**M54 to M6 Link Road**

**TR010054**

**8.8 P(A) Draft Statement of Common  
Ground with Environment Agency**

<b>Version</b>	<b>Date</b>	<b>Status of Version</b>
5 (P07)	12 February 2021	Issue to the ExA for Deadline 6

## Figure 1

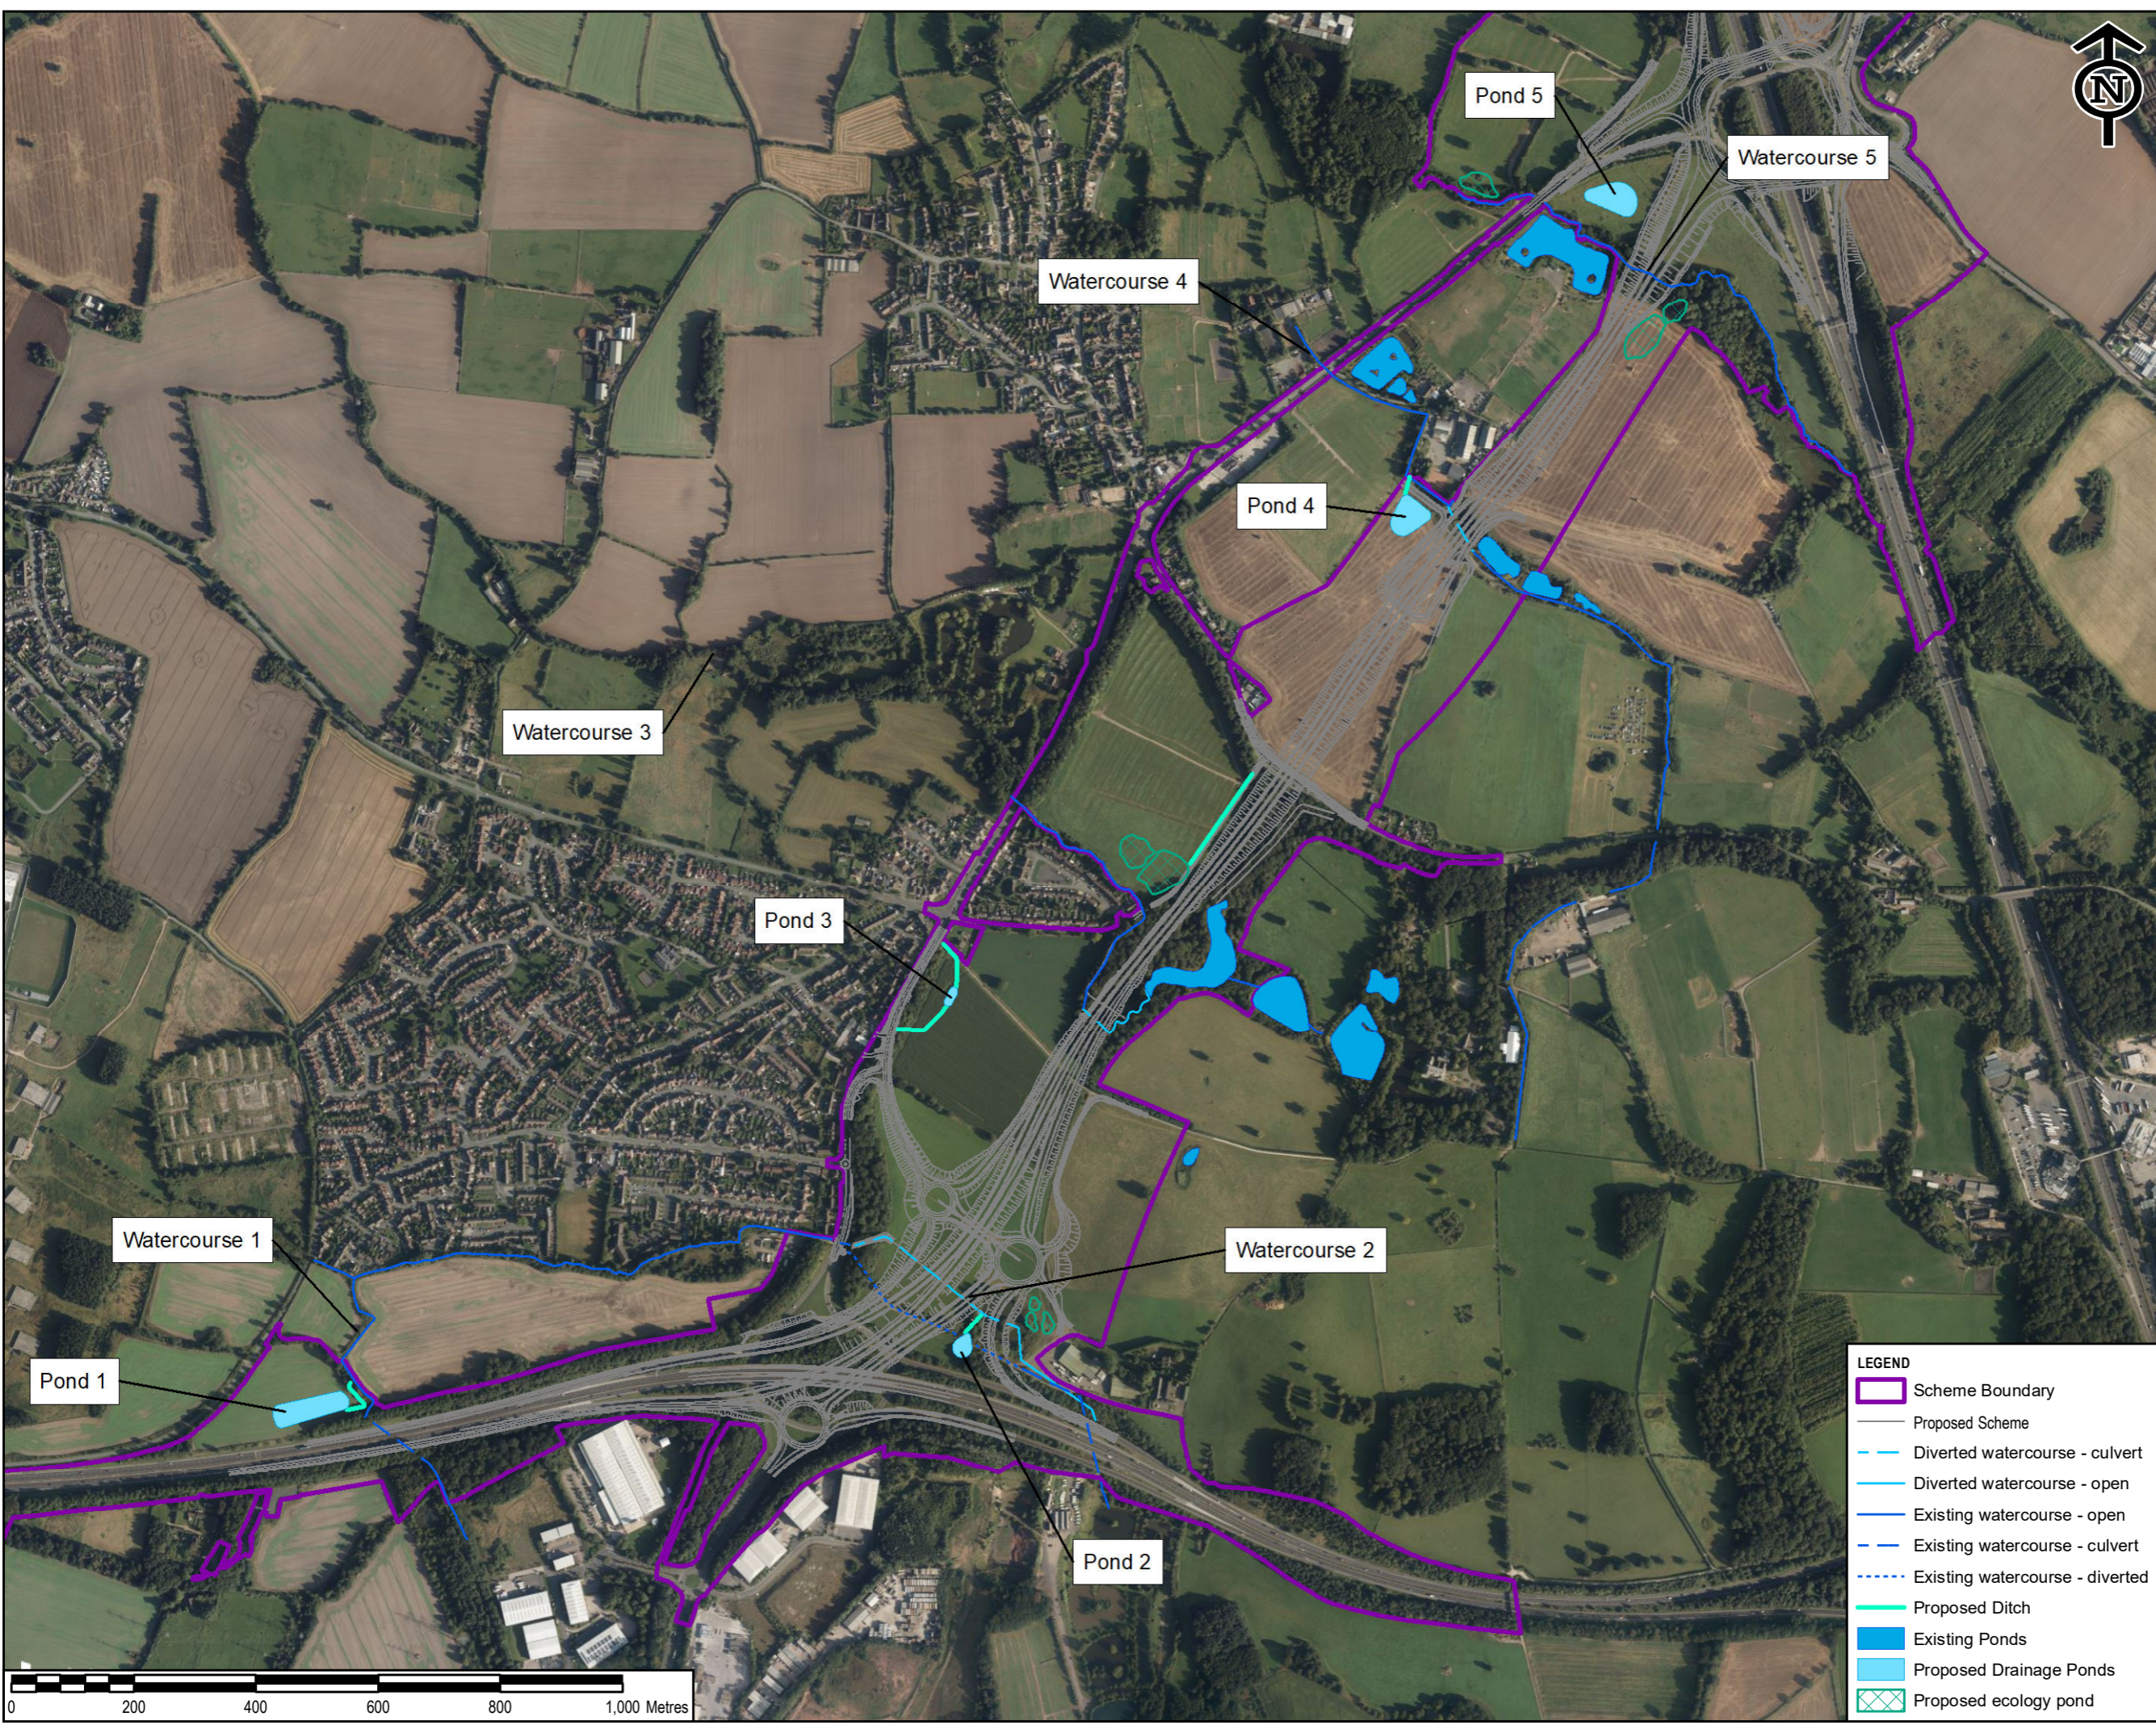
ES Chapter	Paragraph Reference	Sub-section	Environment Agency Comment	Highways England Response	Status	Agreement likely?	
						APP?¹	IP?
				<p>Appendix 13.2: Drainage Strategy [APP-201/6.3] and summarised in paragraphs 13.8.11 to 13.8.20 of Chapter 13 of the ES [APP-052/6.1]. Appendix 13.3: Assessment of Routine Road Runoff and Accidental Spillage Risk (HEWRAT) [APP-202/6.3] presents full details of the water quality risk assessment that has been carried out, which is summarised in paragraphs 13.9.57 to 77 of Chapter 13 of the ES [APP-052/6.1]. Appendix 13.4: Water Framework Directive Assessment [APP-203/6.3] also includes consideration of surface water drainage proposals and the assessment carried out.</p> <p>The previous estimates of the new ditchcourses failed to include the ditch to Watercourse 1 and thus the total length is in fact 483 m of new ditchcourses as opposed to 408 m reported in the ES and associated appendices. This includes 75 m of ditch to Watercourse 1, 32 m to Watercourse 2, 280 m to and from Pond 3 to Watercourse 3, and 96 m to and from Pond 4 to Watercourse 4. In addition, it should be noted that the Scheme will also provide new channels for Watercourse 2 (where it is diverted) and Watercourse 3 (due to the relocation of the impoundment to Lower</p>

ES Chapter	Paragraph Reference	Sub-section	Environment Agency Comment	Highways England Response	Status	Agreement likely?	
						APP?¹	IP?
				<p>Pool), which will also be designed to improve upon the current channel form, with the lengths provided to be confirmed through detailed design and thus not included in the 483 m length stated above (with the recent proposed Scheme design changes 323 m of existing watercourse will be culverted, and a further 30 m affected by the new bridge crossing Watercourse 5 (Latherford Brook).</p> <p>The proposed road drainage networks 5, 8 and 10 (i.e. to Watercourses 2, 3 and 4, respectively) are not reliant on the proposed ditchcourses to provide treatment of highway runoff. Treatment of highway runoff from road drainage network 3 (to Watercourses 1) will primarily be from the proposed wet pond. However, to ensure adequate treatment is provided the proposed ditchcourse from Pond 1 is required to provide some treatment. Overall, as the flow within these ditchcourses will come from highway surfaces via a treatment train, water quality will be influenced by the type and range of chemical compounds that may be found in highway runoff. However, the proposed ditchcourse will still provide biodiversity benefits, and are preferred to</p>
